Report to the Future Melbourne (Planning) Committee

**Planning Permit Application: TP-2015-567,
80-82 Lothian Street, North Melbourne**

17 May 2016

DELEGATED PLANNING APPLICATION REPORT

PLAN Roof
 1:100

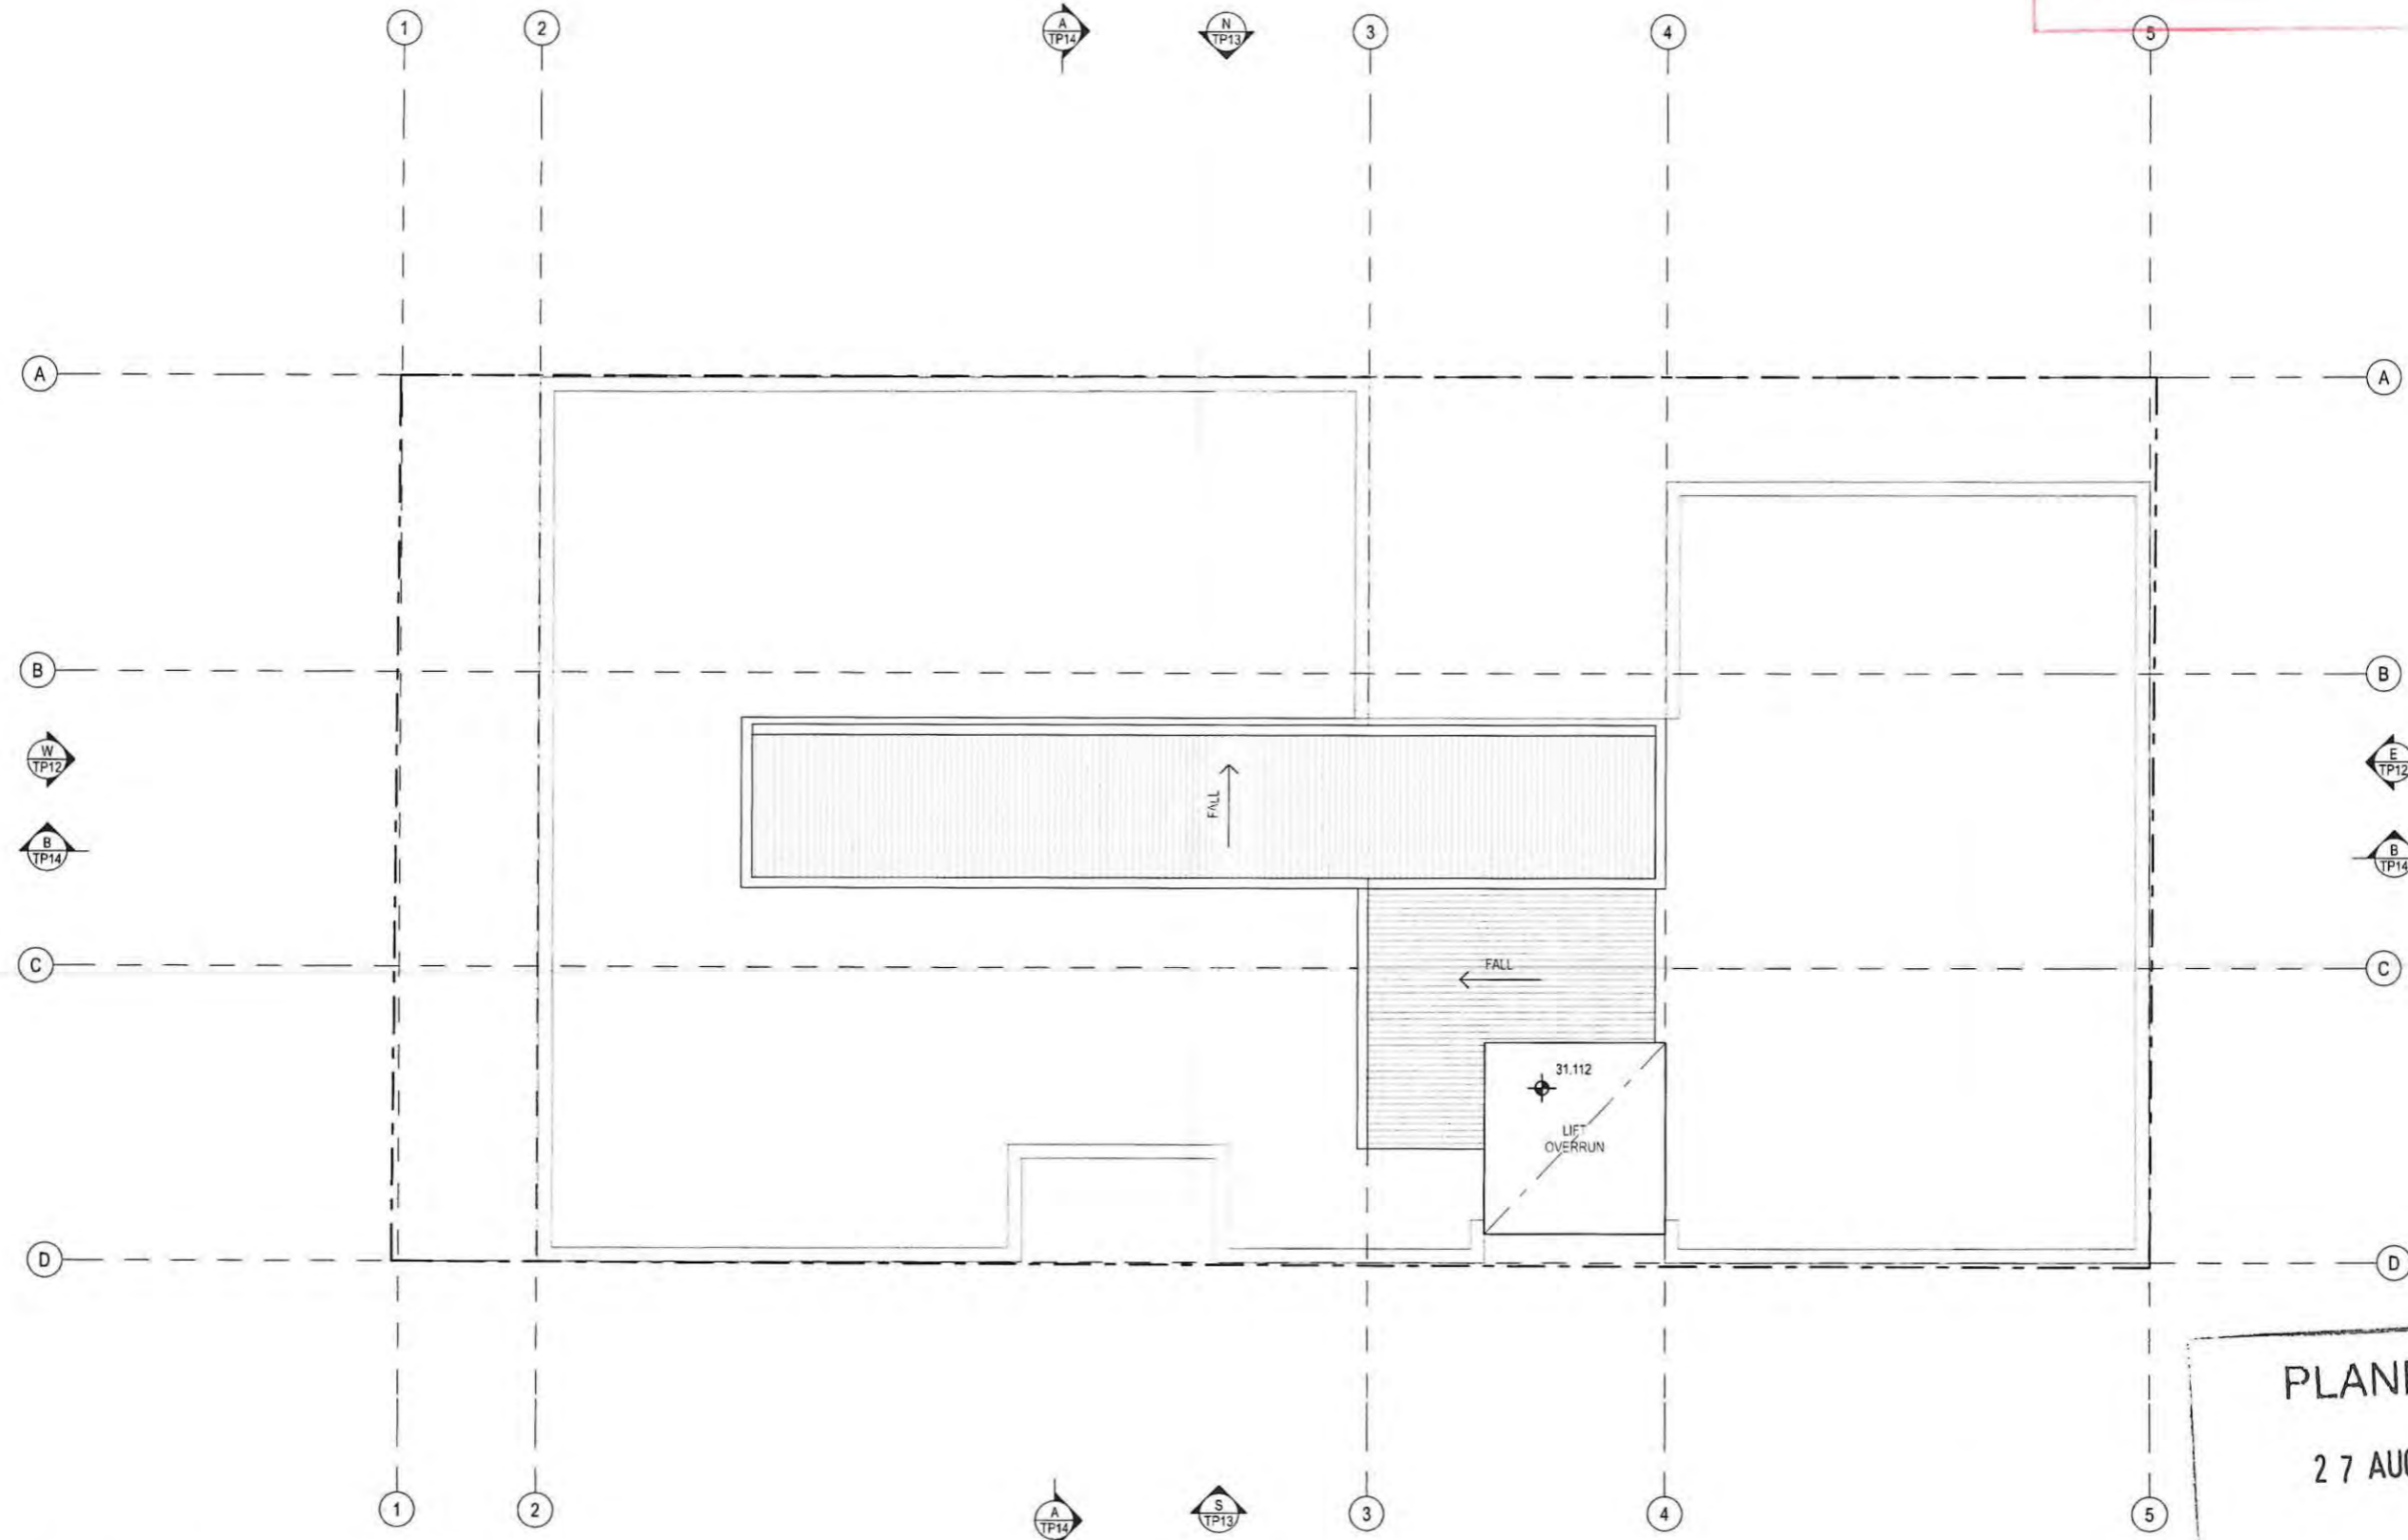
The development as originally proposed is designed in accordance with the supreme court decision, with ‘barriers’ and other architectural features and services above the mandatory height. The draft amended plans reconfigure the rooftop in order to provide no ‘barriers’ to habitable space projecting beyond the 14 metres height limit when measured from the street each street frontage to the midpoint of the block, in accordance with amendment C256. Building services, including stair and lift project beyond the mandatory height limit. Whilst it can be argued that the stair is essential for access to building services, the proposed lift access to the rooftop is a non-essential access service, projecting significantly above the 14 metre height control. This projection appears as a foreign element, and has flow on amenity impacts to the dwellings to the south. It is recommended that a condition of permit require deletion of the lift access to rooftop, so that lift overrun only projects above the height control.

The proposed lift extends significantly beyond the mandatory height limit, and presents as a foreign element from the public realm and private property. It is recommended that lift access finish at the upper residential level (Level 3 as notated on the plans) and any projection beyond the roof level be minimised as lift overrun only. This will result in a reduction in the lift projection by approximately 3 metres.

- b) Setback of the level 1 balconies one metre from the western boundary.
- c) Re-arrangement of the rooftop deck and services space generally in accordance with draft plans dated 22 February 2016.

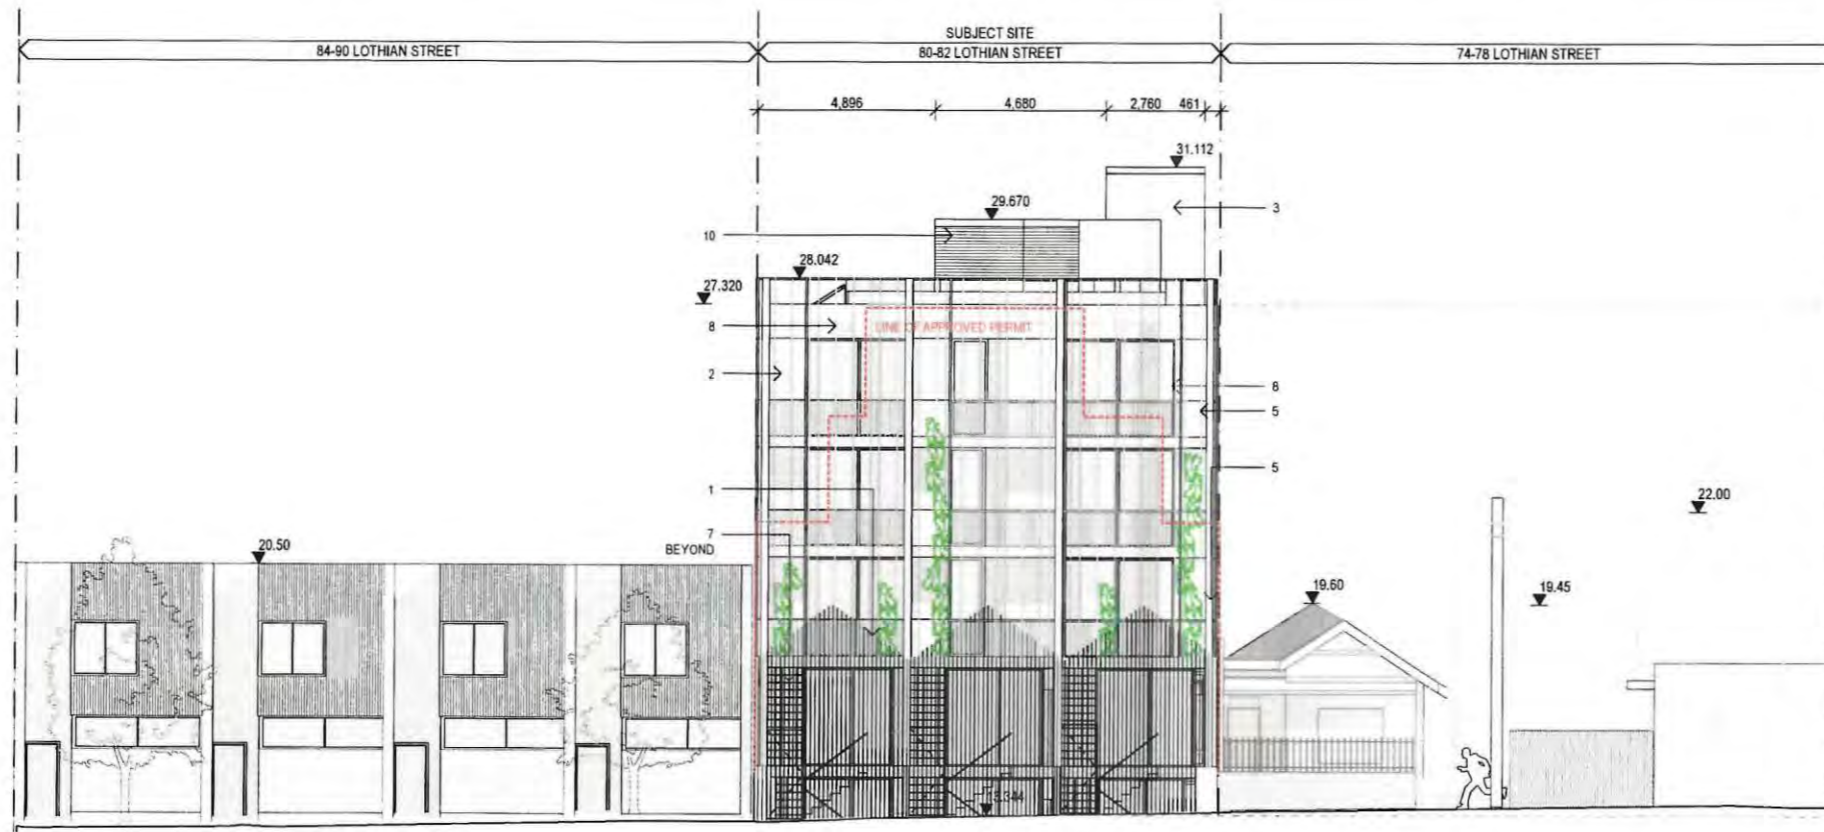
MEASURED FROM THE MID POINT OF LOTHIAN STREET FRONTAGE. MAX 14M CAN NOT BE EXCEEDED DD032

ELEVATION West Elevation - Proposed
1:200

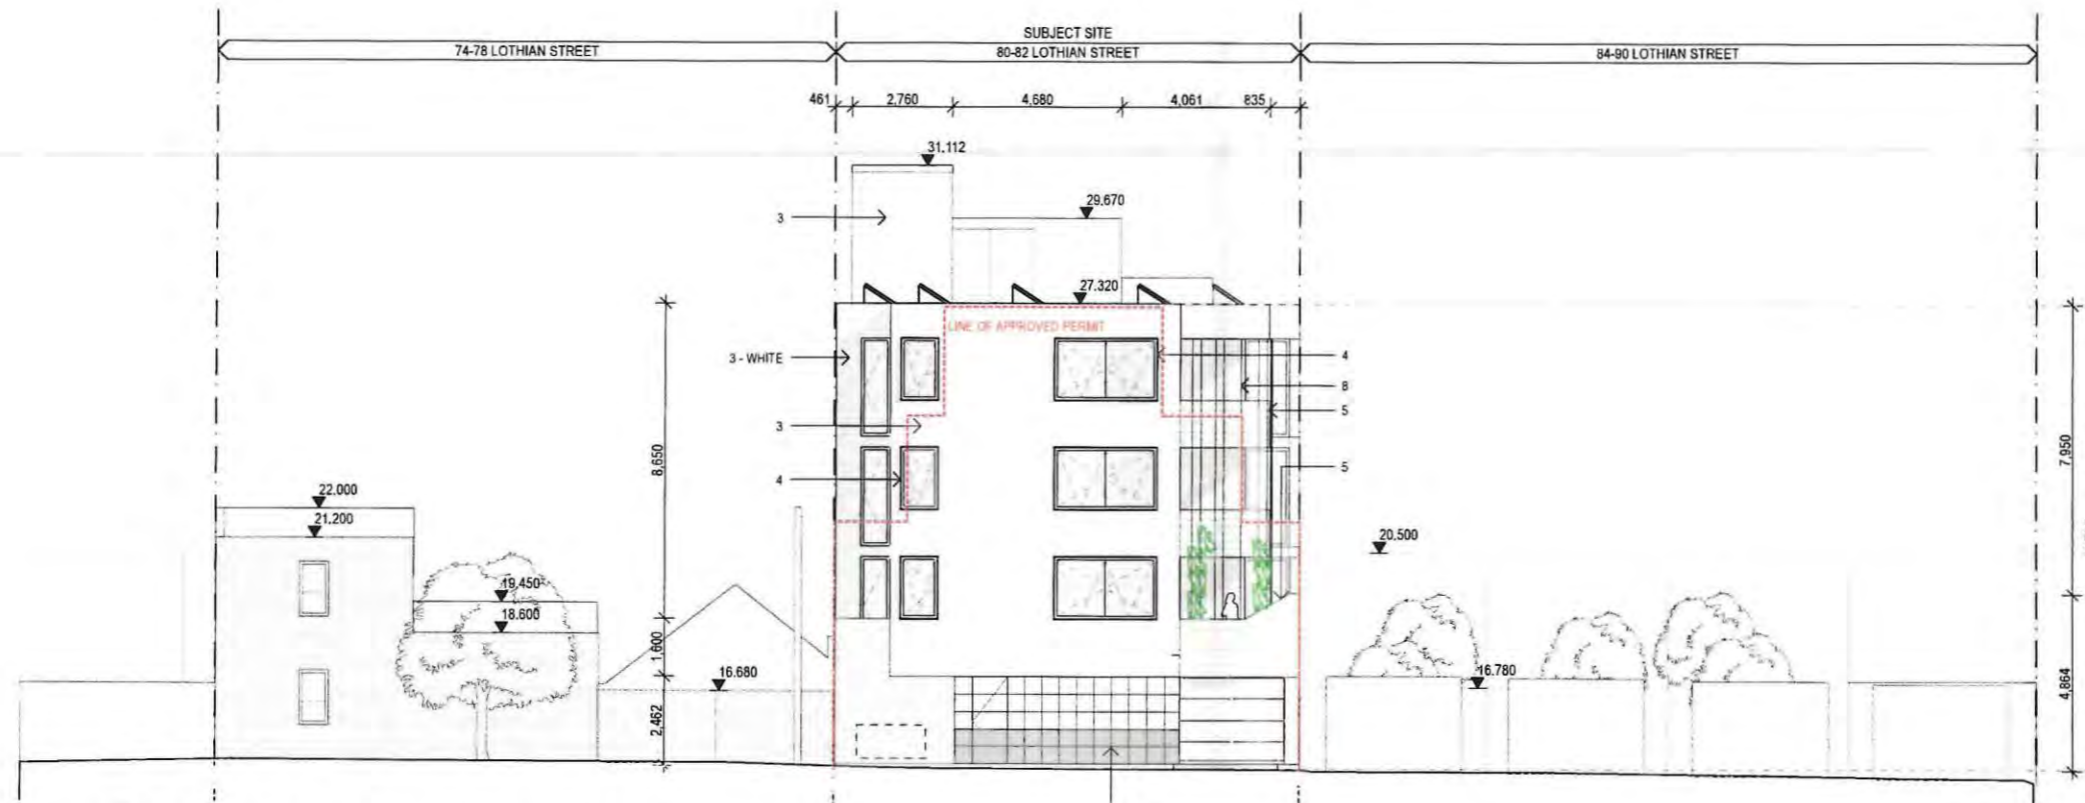
Considering the provision of a transition in height only (overshadowing and visual bulk are considered below in chapter 14.3), the proposal should provide some setback at the upper floor to Lothian Street to provide a transition in scale to the single storey dwelling to the south.

It is recommended a condition of permit require a setback of 1.64 metres from the southern boundary (in line with the light court) up until the depth of the light court. This will result in the fourth floor southern corner having limited visibility directly across Lothian Street, and provide a transition of two stories at the Lothian Street end when viewed from oblique angles before stepping up to the maximum height limit.
